KAKE DOLPHIN REPLACEMENT & BRIDGE REHAB
FED. NO. STP-0939(6) ~ PROJECT NO. 75525
QUANTITIES & GENERAL NOTES

KAKE DOLPHIN REPLACEMENT & BRIDGE REHAB
FED. NO. STP-0939(6) ~ PROJECT NO. 75525
DOLPHIN STRUCTURE PLAN & ELEVATION

KAKE DOLPHIN REPLACEMENT & BRIDGE REHAB
PROJECT NO. STP-0939(6)/75525
DOLPHIN STRUCTURE CAP DETAILS

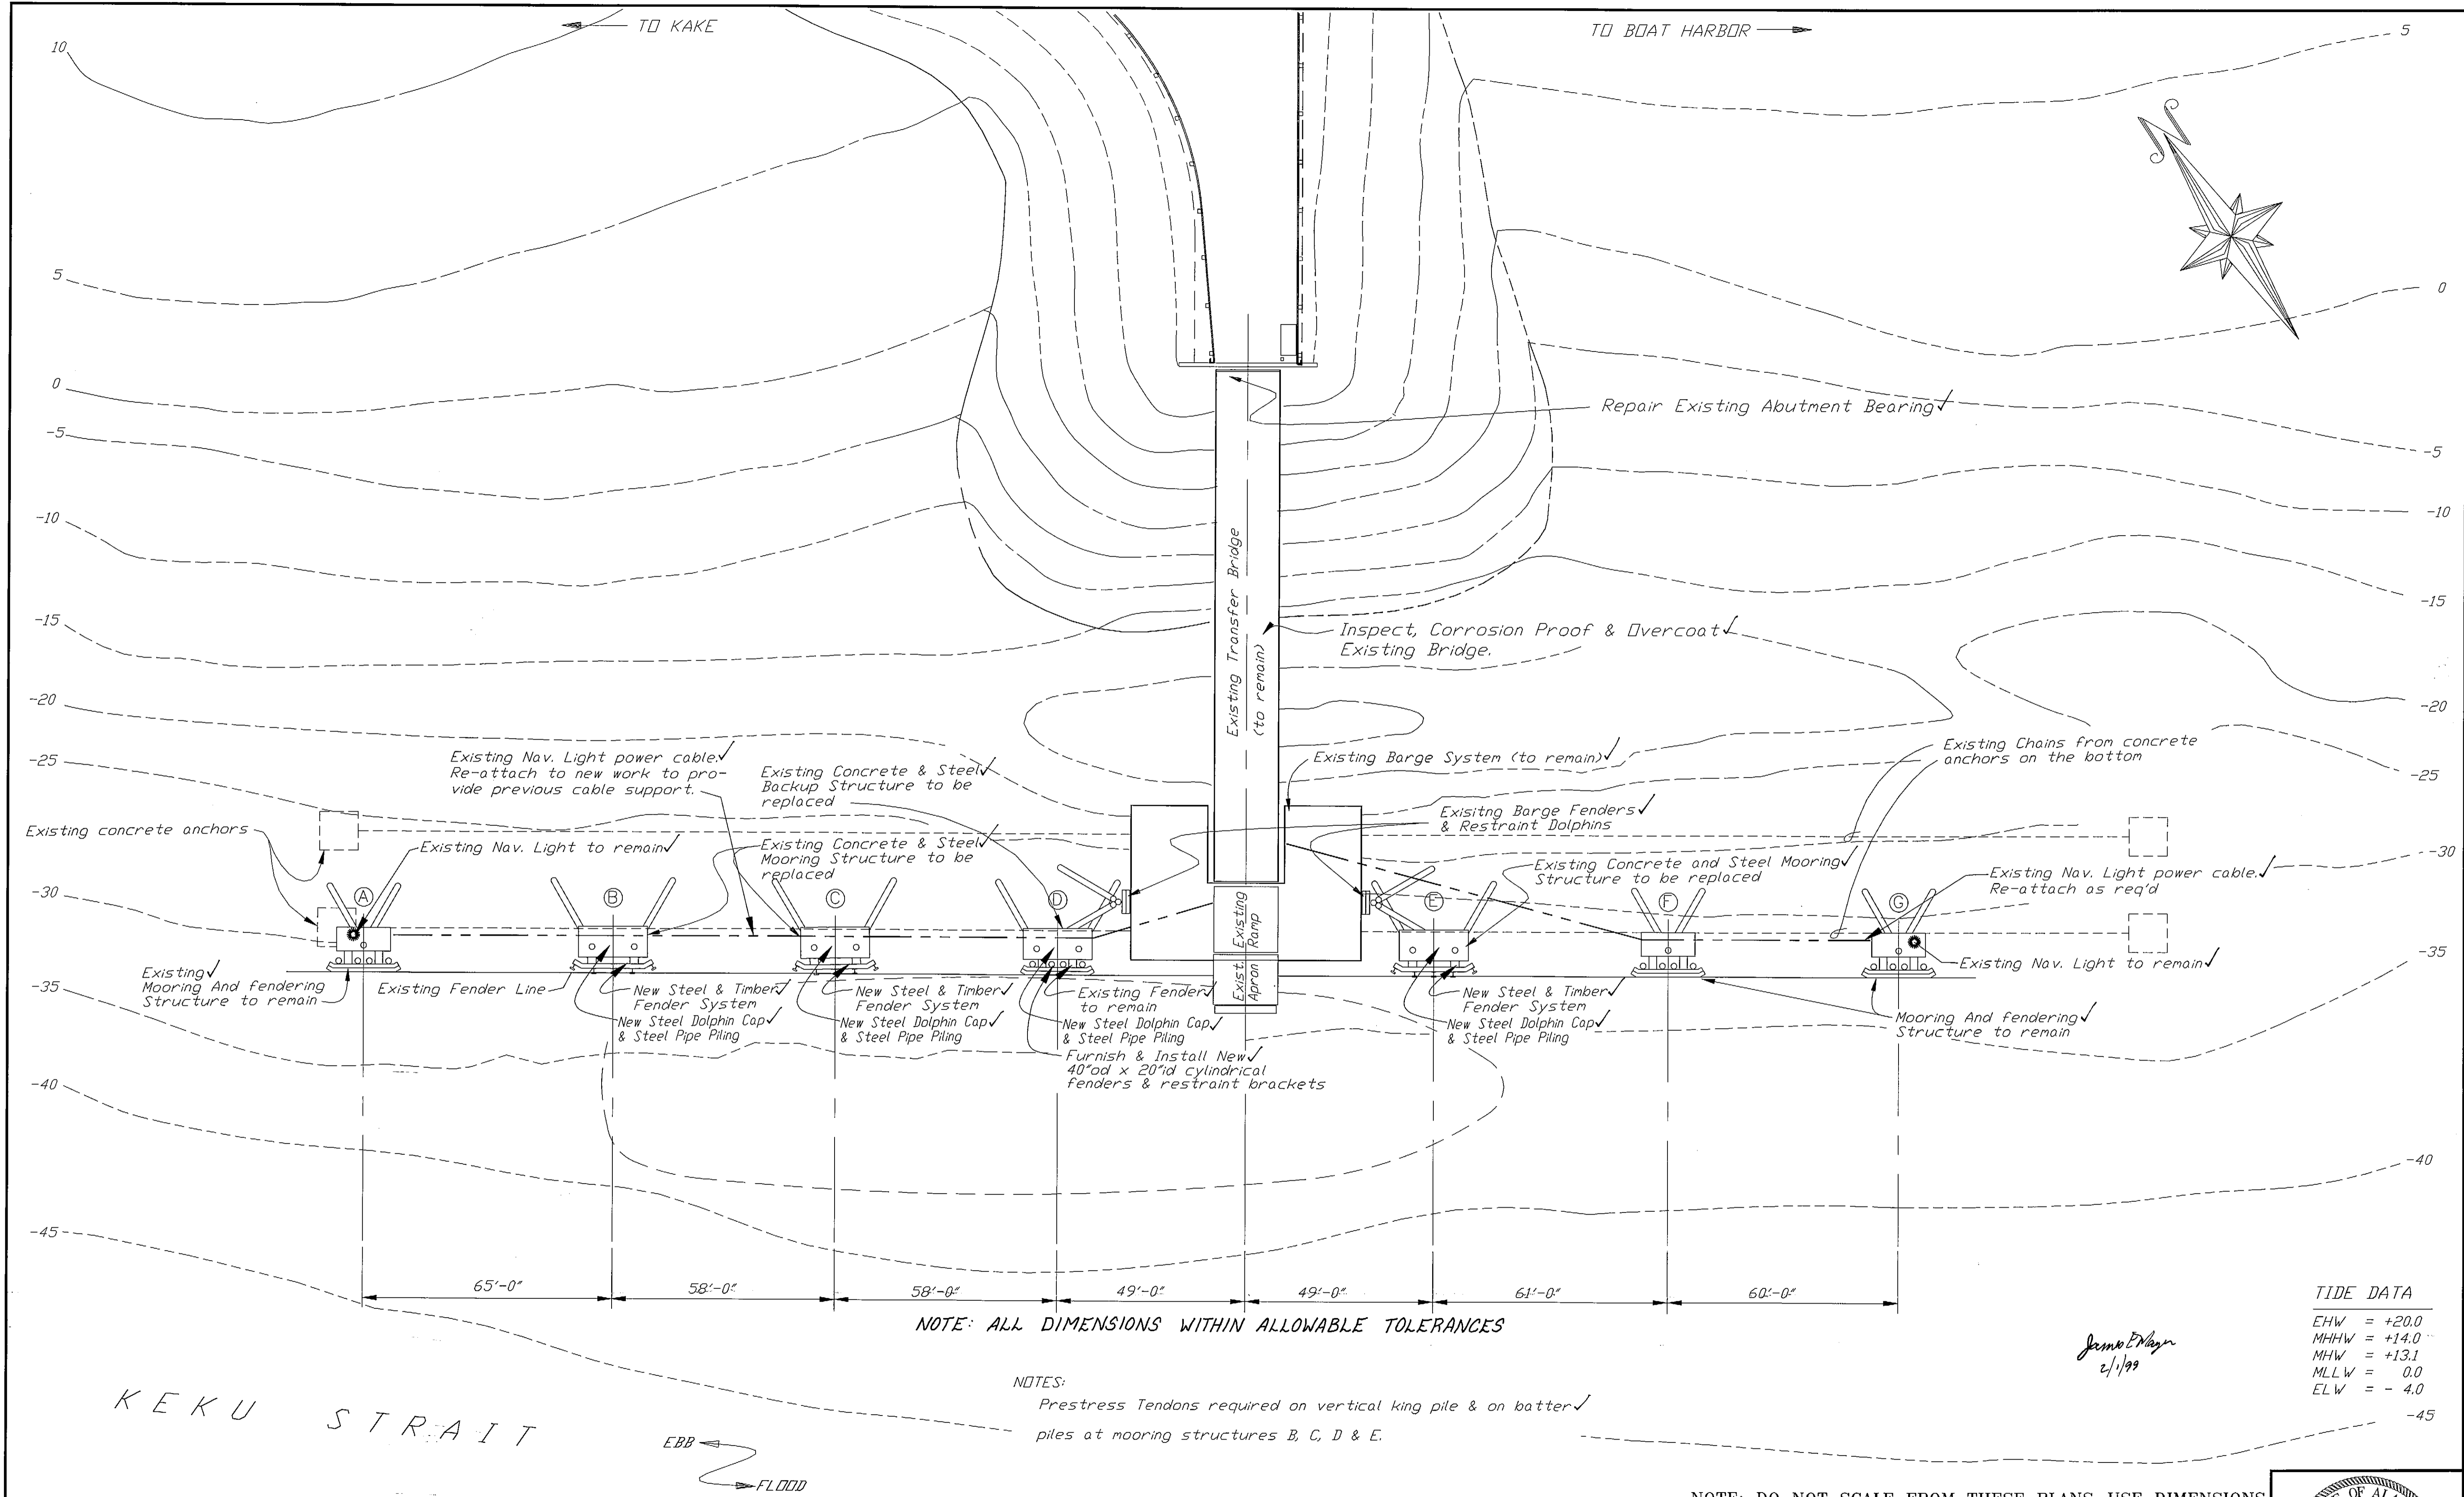
ITEM NO.	ITEM	PAY UNIT	ESTIMATED QUANTITIES	UNIT	FINAL QUANTITY
110	Mobilization & Demobilization	L.S.	All Req'd		✓
111(1)	Erosion & Pollution Control, Administration	L.S.	All Req'd		✓
111(2)	Erosion & Pollution Control NONE REQUIRED	C.S.	All Req'd		✓
116	Furnishing And Maintaining Field Office	L.S.	All Req'd		✓
120(1)	DBE Adjustment NONE	C.S.	All Req'd		✓
201	Removal Of Structures & Obstructions	L.S.	All Req'd		✓
301(1)	18"Ø x 3/8" wall Structural Steel Pipe Piles, Furn.	L.F.	1700		1,709.8
301(2)	18"Ø x 3/8" wall Structural Steel Pipe Piles, Driven	EA.	24		✓
302(1)	Mooring Structure Cap, Furn, Fabr. & Erected	EA.	4		✓
302(2)	Mooring Structure Fender System, Furn, Fabr. & Erected	EA.	3		✓
302(3)	Bridge Bearing Repair	L.S.	All Req'd		✓
303(1)	Corrosion Proof Existing Transfer Brige	L.S.	All Req'd		✓
303(2)	Overcoat Existing Bridge	L.S.	All Req'd		✓
306	Pre-stressed Pile Anchors DELETED BY C.O. #1	EA	12

NEW ITEMS ESTABLISHED BY CHANGE ORDER				
ITEM NO.	ITEM	CHANGE ORDER NO.	UNIT	QUANTITY
308(1)	PRE-STRESSED PILE ANCHORS	1	EACH	12
302(4)	TRANSFER BRIDGE RAILING	2	L.S.	ALL REQ'D.
302(5)	TRANSFER BRIDGE CONNECTION WELDMENT	3	L.S.	ALL REQ'D.
604(1)	BRIDGE INSPECTION SURVEY AND REPORT	4	L.S.	ALL REQ'D.
660(1)	WINDCONE, FURNISHED	5	L.S.	ALL REQ'D.

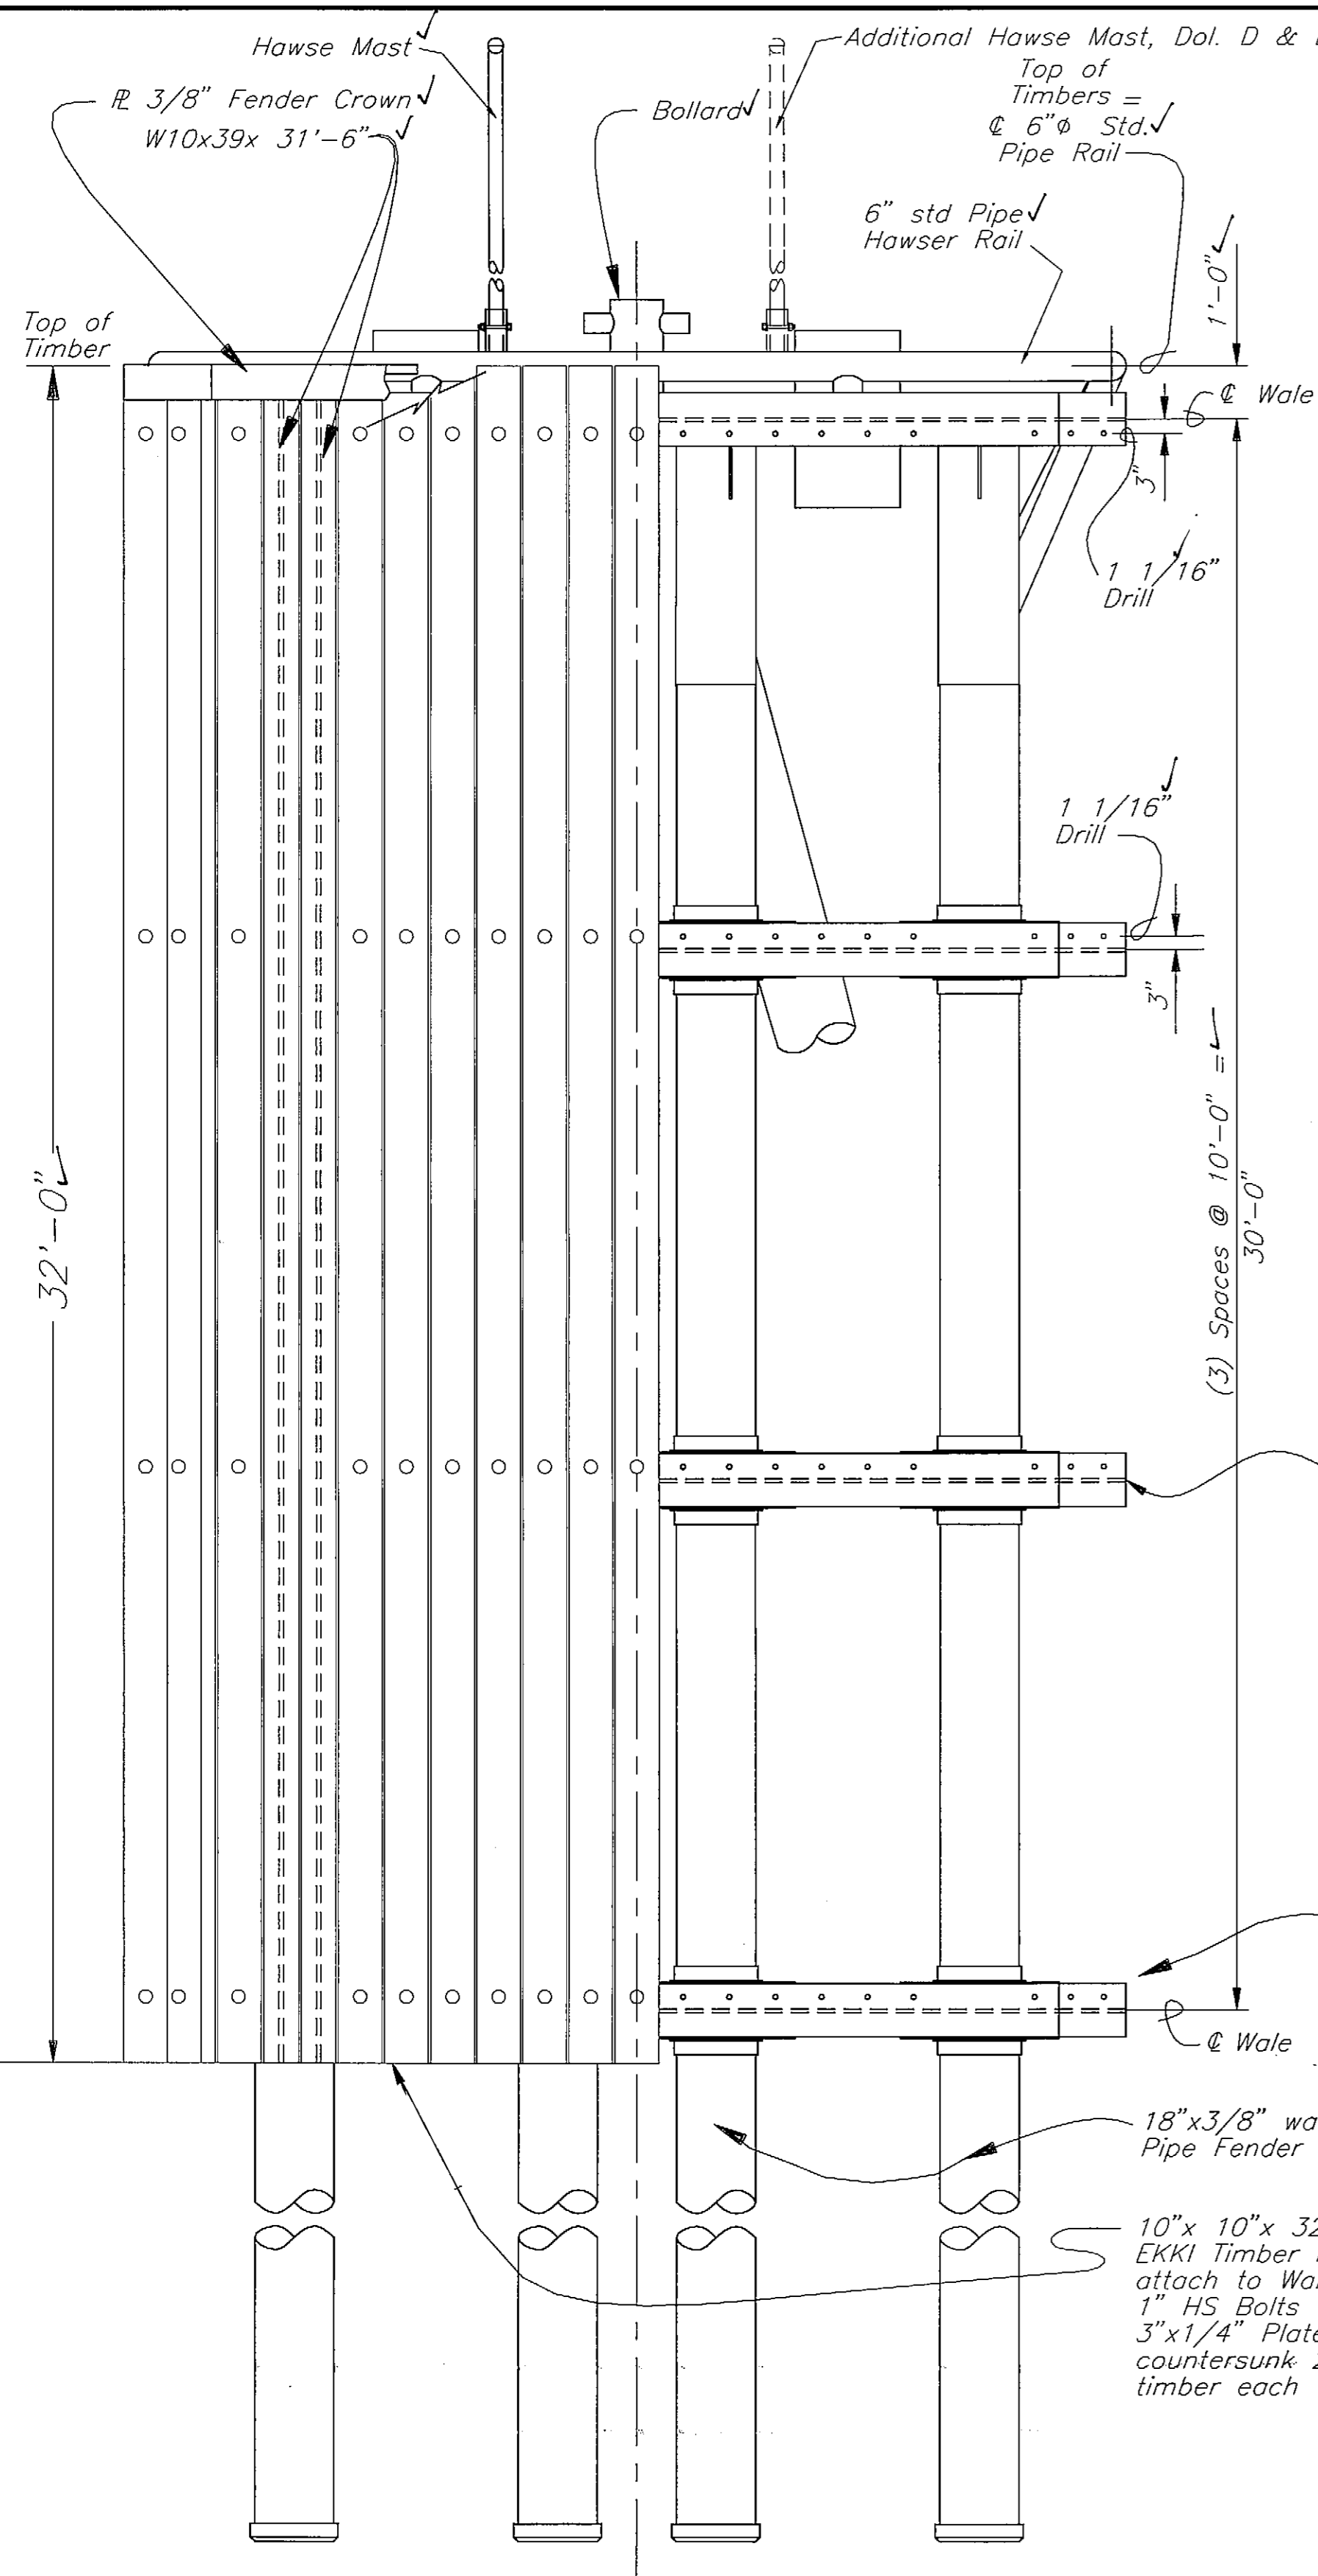
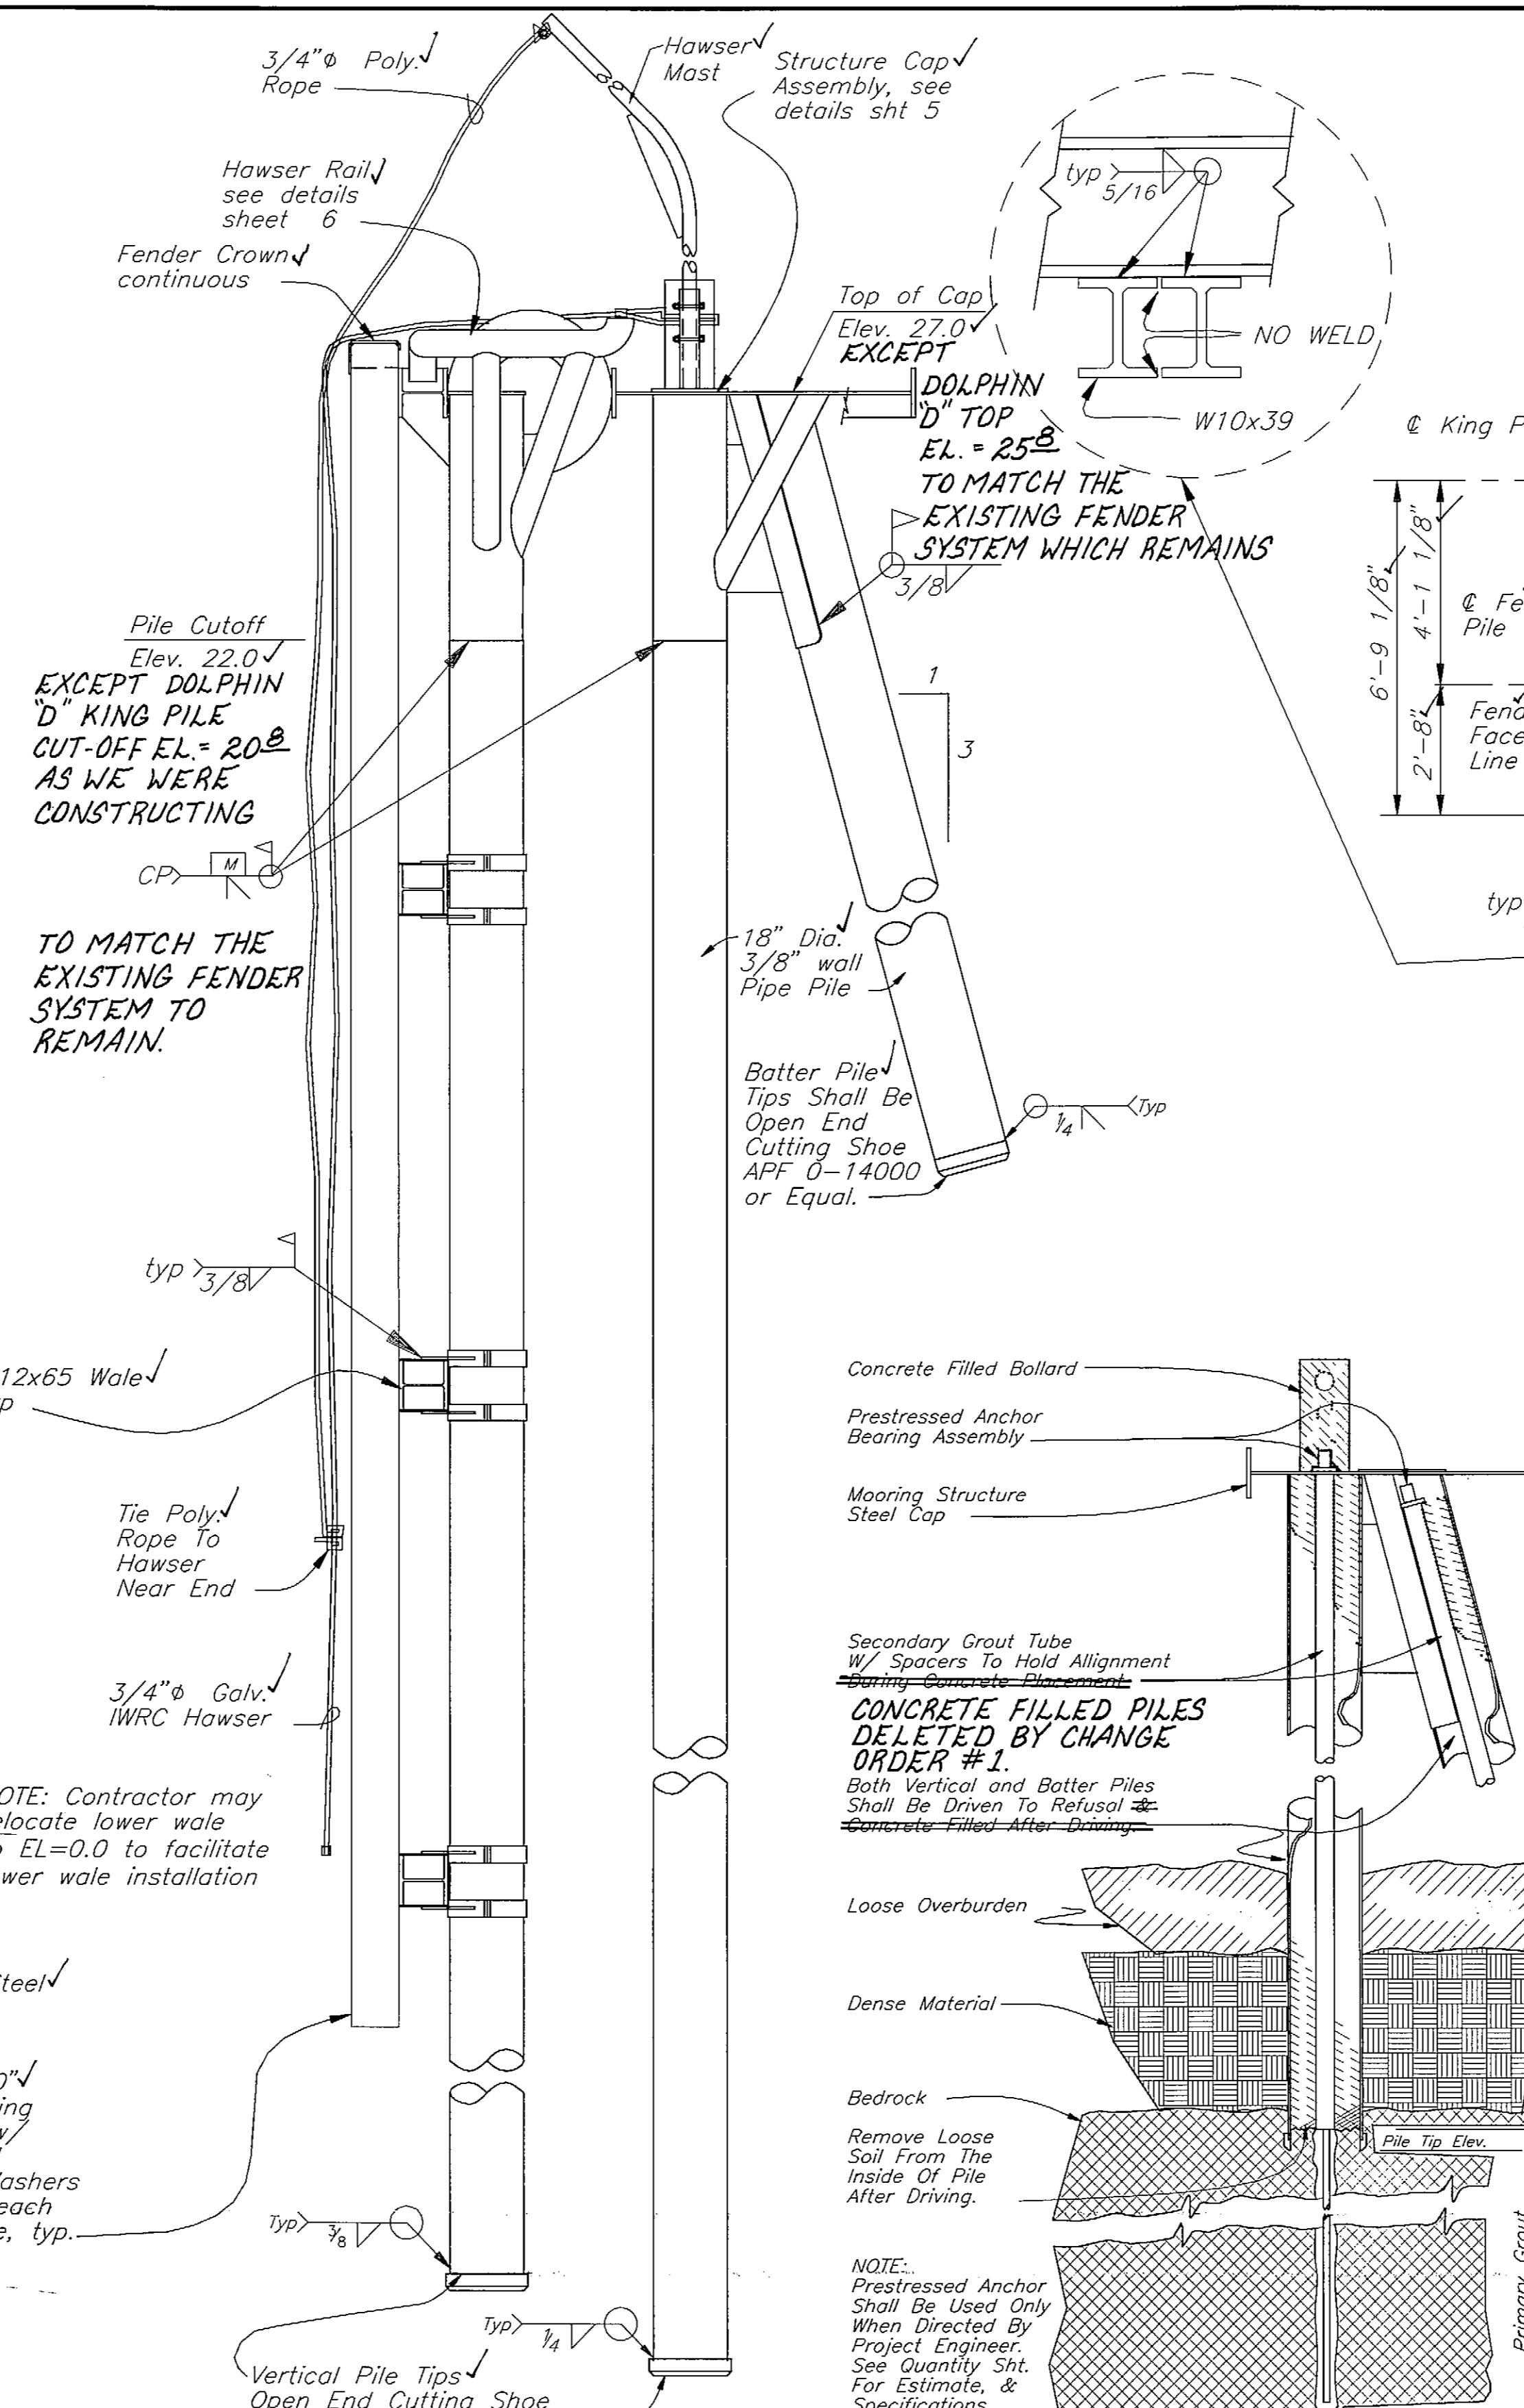
NOTE: ALL DIMENSIONS WITHIN ALLOWABLE TOLERANCES
